PUYALLUP 2ND STREET APARTMENTS  
A PORTION OF THE NW 1/4 OF THE NW 1/4 OF SEC. 27, TWN. 20 N., RGE. 04 E. W.M.  
CITY OF PUYALLUP, PIERCE COUNTY, WASHINGTON.

SITE DEVELOPMENT PERMIT SET

GRADING AND  
DRAINAGE PLAN

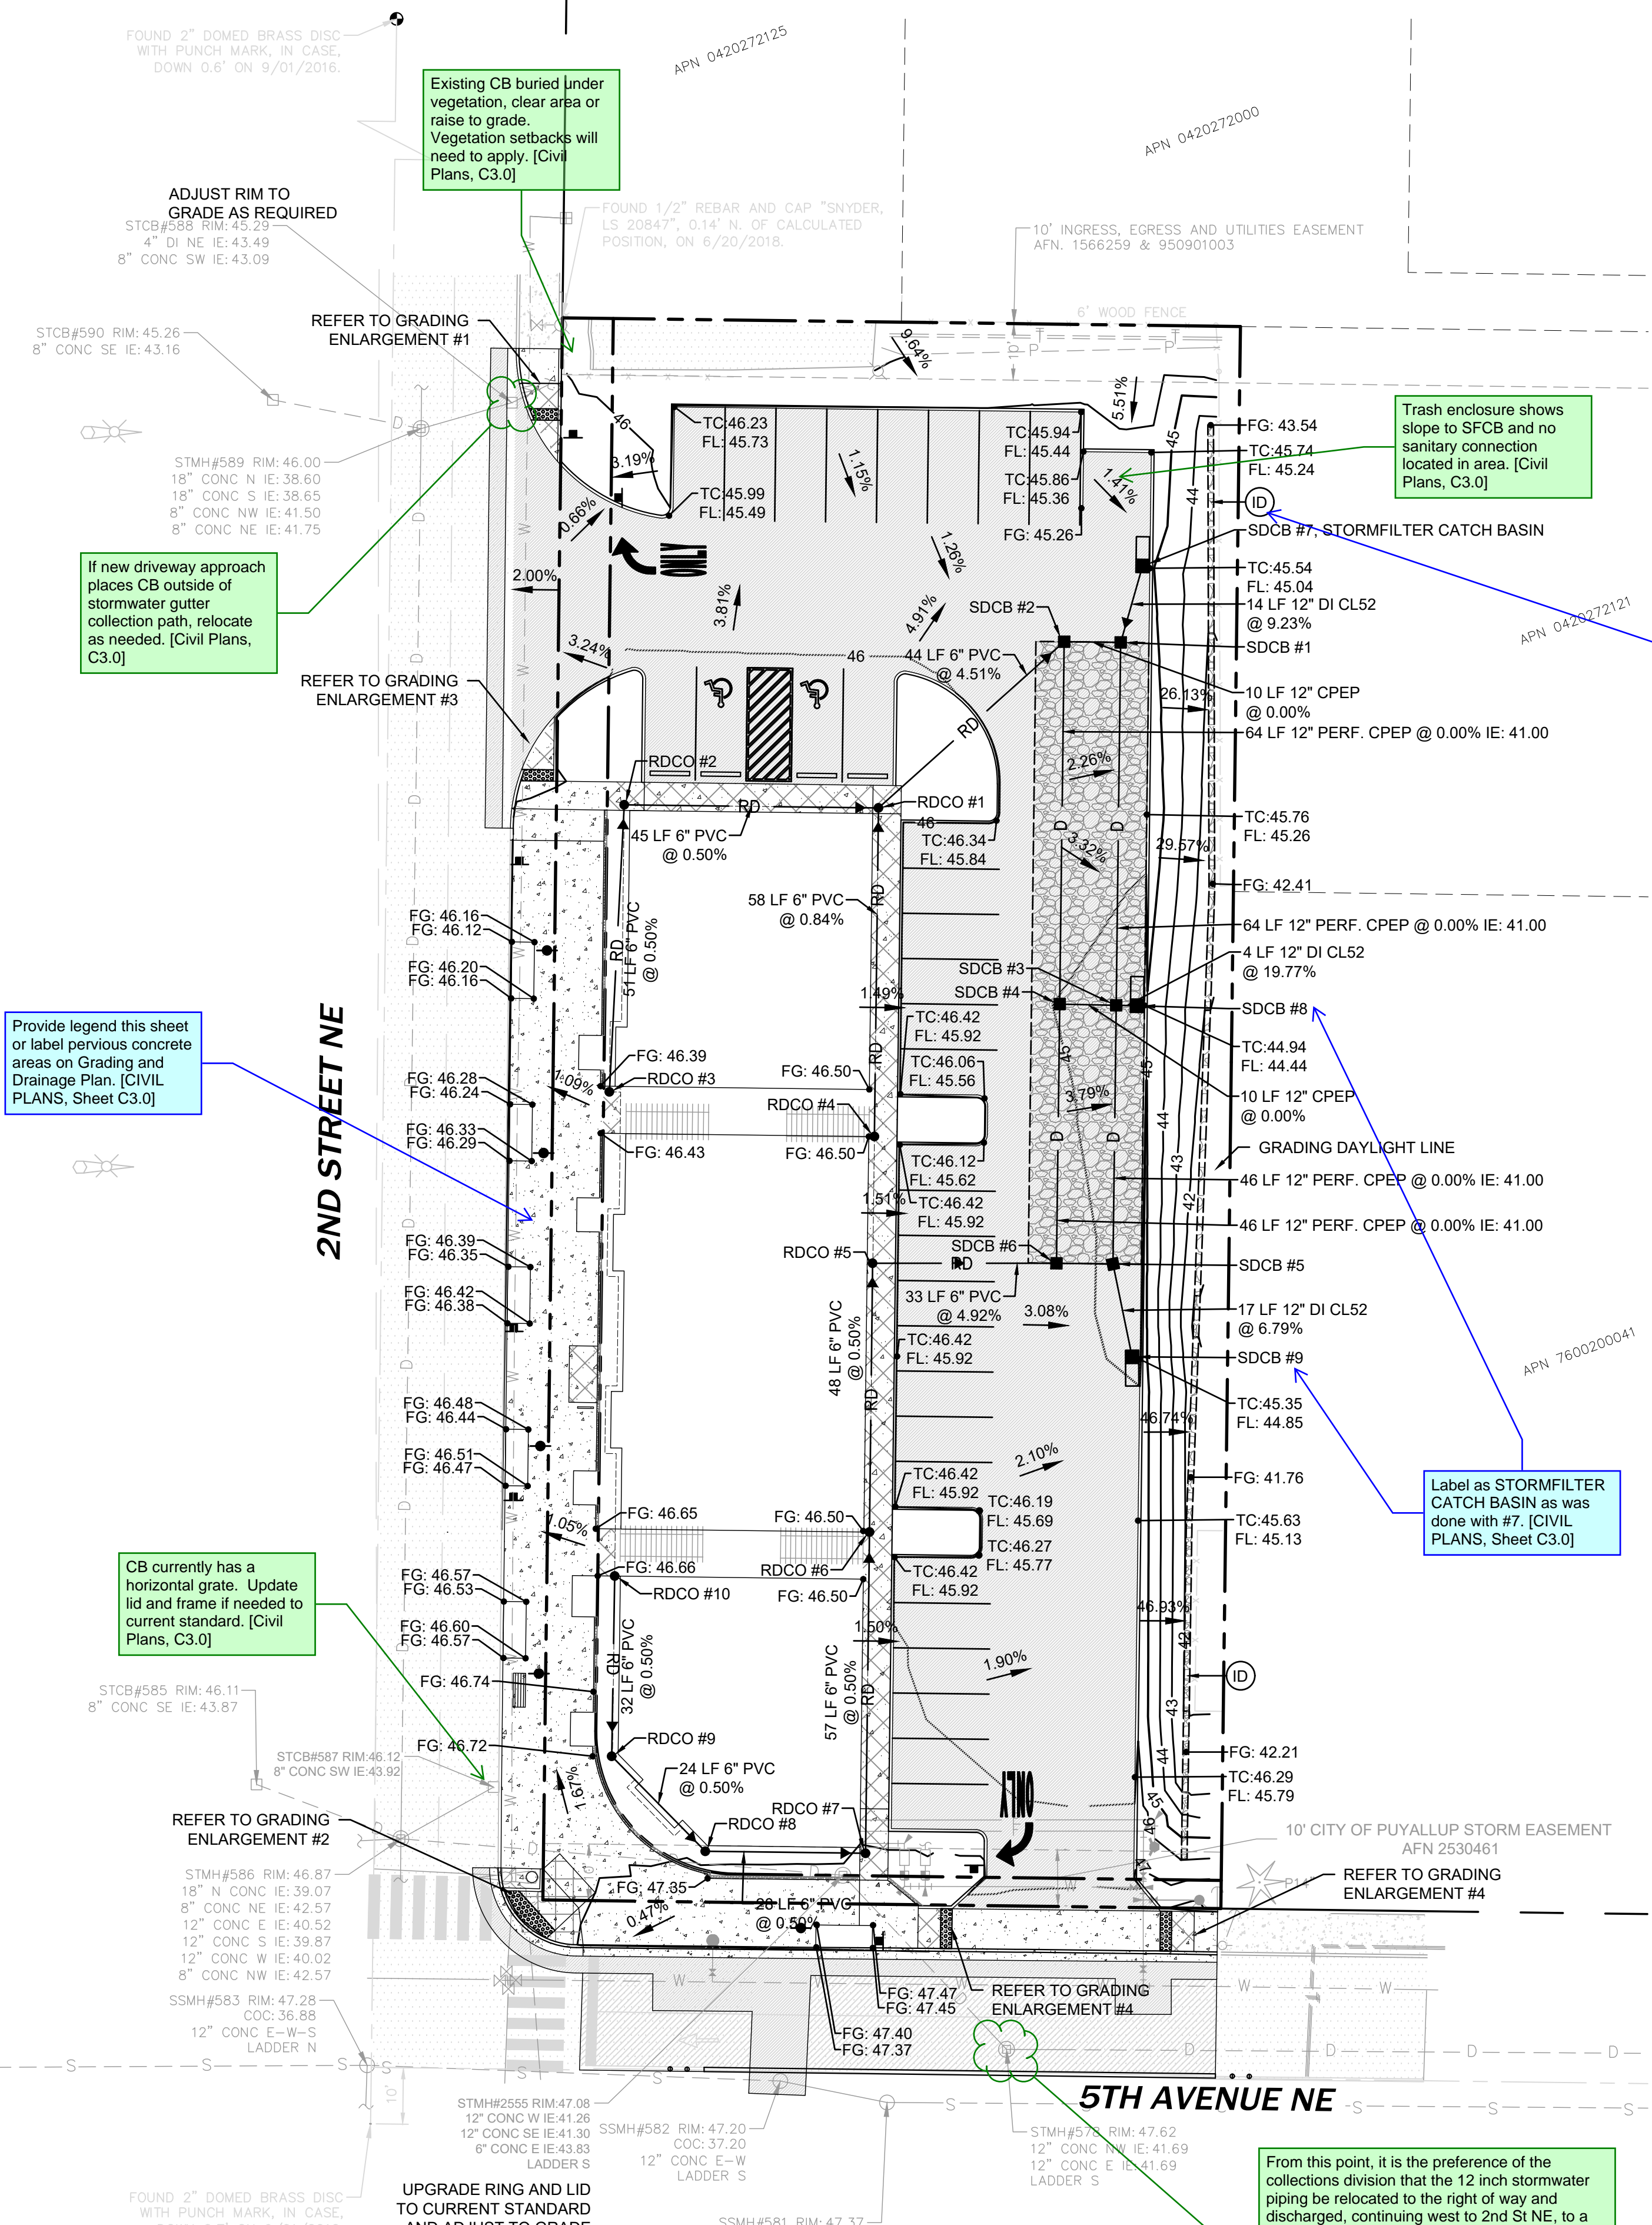
WSDOT Standard Plans  
F-45.10-04 states if this is  
more than 5' DWS should  
be at back of curb C 3.0  
SH

Label as STORMFILTER  
CATCH BASIN as was  
done with #7. [CIVIL  
PLANS, Sheet C3.0]

From this point, it is the preference of the  
collections division that the 12 inch stormwater  
piping be relocated to the right of way and  
discharged, continuing west to 2nd St NE, to a  
new structure. The ability to repair, replace or  
maintain the existing stormwater system in its  
current location would be greatly impacted with  
the proposed building structure so close. The  
then abandoned, existing pipes and manhole  
should be removed. [CIVIL PLANS, C3.0]
